Sanitary Pulsation Dampener

Per the attached, there have been some changes and clarifications in the instruction sheet supplied with the pulsation dampener.

Part No. 898122

FIGURE 1
OLD STYLE

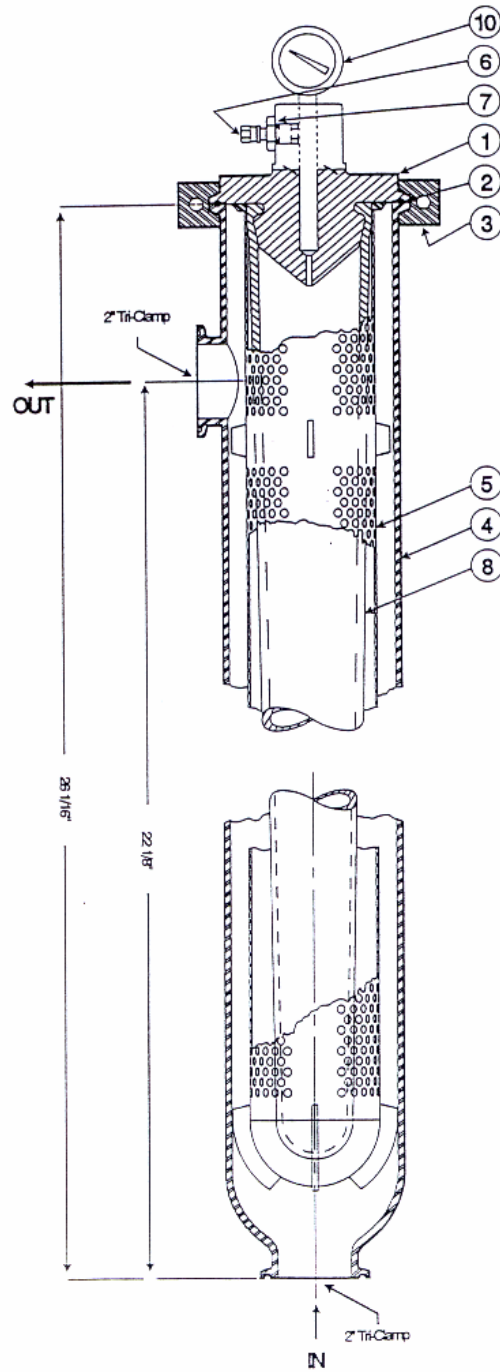
The maximum allowable "system" operating pressure is 300 psi. This requirement is established by the tendency of the bladder to peel off the adapter plate, when the system pressure is more than three times the pre-charge gas pressure.

Also, we have determined the cause of the bladder failure to be inadequate air pressure. If the air pressure is not maintained, the bladder tends to fold over in the air inlet hole. The bladder then develops a circular cut on the inside about one inch from the opening. The inside lip of the air inlet hole can be smoothed to remove any sharp edges. We suggest that you:

1. Check your air pressure daily;
2. Check for leaks with a soap and water solution;
3. Do not use a constant-pressure-regulated airline that is permanently connected.

See Assembly Instruction #3. The "folded" end of the Bladder is held against the boss of the Adapter Plate, and then is unfolded over the boss.
